SUBJECT: EMERGENCY TECHNICAL SPECIFICATION CHANGE, REACTOR COOLANT SYSTEM  
FLOW MEASUREMENT UNCERTAINTIES (TAC NO. 69804)

RE: SALEM GENERATING STATION, UNIT NO. 2

AMENDMENT TO FACILITY OPERATING LICENSE

Amendment No. 64  
License No. DPR-75

Figure 3.2-3  
RCS TOTAL FLOWRATE VERSUS R - FOUR LOOPS  
IN OPERATION

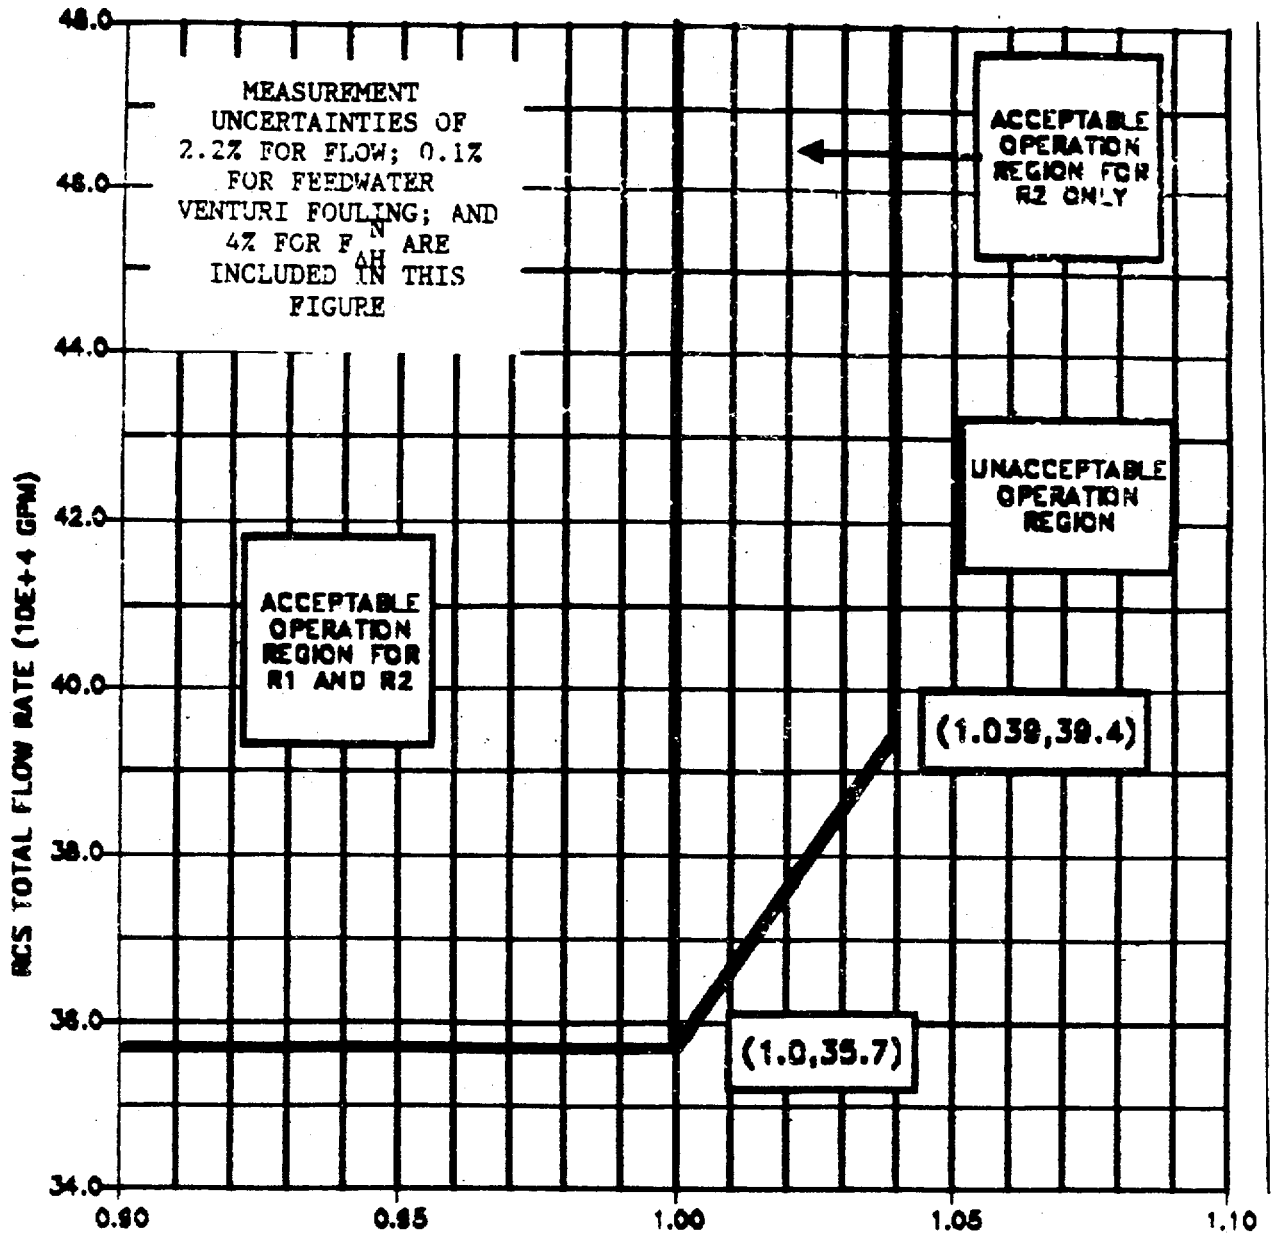
d.  $F_{\Delta H}^N$  = Measured values of  $F_{\Delta H}^N$  obtained by using the movable incore detectors to obtain a power distribution map. The measured values of  $F_{\Delta H}^N$  shall be used to calculate R since Figure 3.2-3 includes penalties for undetected feedwater venturi fouling of 0.1% and for measurement uncertainties of 2.2% for flow and 4% for incore measurement of  $F_{\Delta H}^N$ .

By letter dated October 19, 1988 (Ref. 6) and supplemented by letter dated October 26, 1988 (Ref. 6) Public Service Electric and Gas Company (PSE&G), the licensee, requested an Emergency Licensing Amendment to Facility Operating License DPR-75 for Salem Generating Station Unit 2. The proposed amendment presented changes to the Technical Specifications due to a reduction of the flow measurement uncertainty value from 3.5% to 2.2% (not including a 0.1% feedwater venturi fouling penalty).

The licensee does not intend to revise the value of thermal design flow used in the DNBR analysis. The requested change is only being applied to Figure 3.2-3 and the resultant value of minimum allowable RCE flow. The net result of the requested change is to redefine the reference point but maintain the magnitude of the existing margin of safety.

When RCS flow rate and  $F_{\Delta H}^N$  are measured, no additional allowances are necessary prior to comparison with the limits of Figure 3.2-3. Measurement errors of 2.2% for Reactor Coolant System total flow rate, 0.1% for feedwater venturi fouling, and 4% for  $F_{\Delta H}^N$  have been allowed for in the determination of the design DNBR value.
